UNITED STATES PATENT AND TRADEMARK OFFICE

APPLICATION NO.	FILING DATE	FIRST NAMED INVENTOR	ATTORNEY DOCKET NO.	CONFIRMATION NO.
10/526,364	09/06/2005	Dietmar Pennig	7202-78	3372
30448	7590	12/24/2008	EXAMINER	
AKERMAN SENTERFITT P.O. BOX 3188 WEST PALM BEACH, FL 33402-3188			WOODALL, NICHOLAS W	
ART UNIT		PAPER NUMBER		
3775				
MAIL DATE		DELIVERY MODE		
12/24/2008		PAPER

DETAILED ACTION

Figure 1

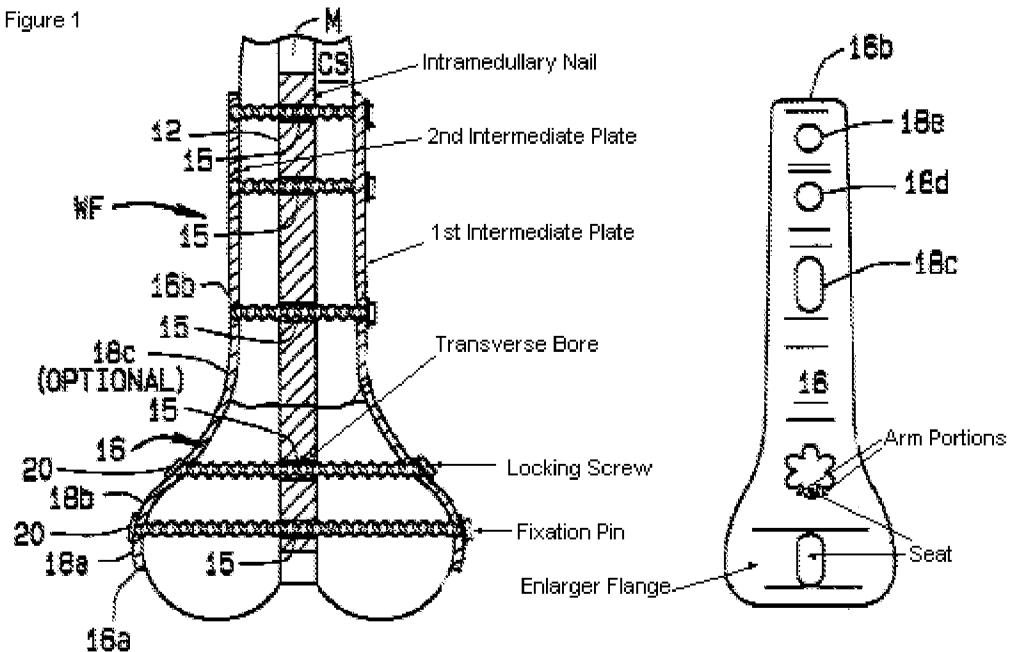
Chow discloses a device comprising at least one humeral nail, at least one fragment fixation pin, and at least one rounded intermediate plate element (see Figure 1 below). The humeral nail includes at least one transverse hole that allows the passage of a locking screw that includes a screw head and a screw body. The at least one intermediate plate comprises an enlarged flange portion and two arm portions extending from the flange portion to define a longitudinal direction, wherein the intermediate plate is placed between the screw head of the locking screw and the surface of the bone such the screw head abuts the intermediate plate. The intermediate plate is slightly curved in the longitudinal direction to allow the plate to conform to the surface of the bone. The two arm portions can be positioned astride the screw body of the locking screw prior to the final fastening of the locking screw head and present rounded ends. The fragment fixation pin includes a final threaded portion having a diameter smaller than the

diameter of the seat, wherein the fixation pin is passed through a seat in the enlarged flange portion of the intermediate plate element and is inserted into the bone. The seat includes at least one hole in the enlarged flange portion and at least one hole formed in the elongated arms portions. The device further comprises a second intermediate plate inserted between the screw head of a second locking screw and the surface of the bone. The transverse hole of the nail includes at least a couple of opposite holes that define the transverse hole. Chow discloses a method of using the device as described above wherein the device can be used in any area of the body, i.e. the humerus. Therefore, Chow discloses a method of using the device on the humeral bone. Chow fails to disclose the device wherein the transverse bore includes an internal partially threaded portion, the second intermediate plate element being larger than the first intermediate plate element, and the arm portions of the intermediate plate element being larger than the arm portions of the first intermediate plate portion. Wagner teaches a device including a transverse bore including an internal partially threaded portion, wherein the portion nearest the screw head includes the partial threading in order to engage and fix a threaded bone screw with respect to the device. It would have been obvious to one having ordinary skill in the art at the time the invention was made to provide the device of Chow wherein the transverse bore includes an internal partially threaded portion in view of Wagner in order to engage and fix a threaded bone screw with respect to the device.
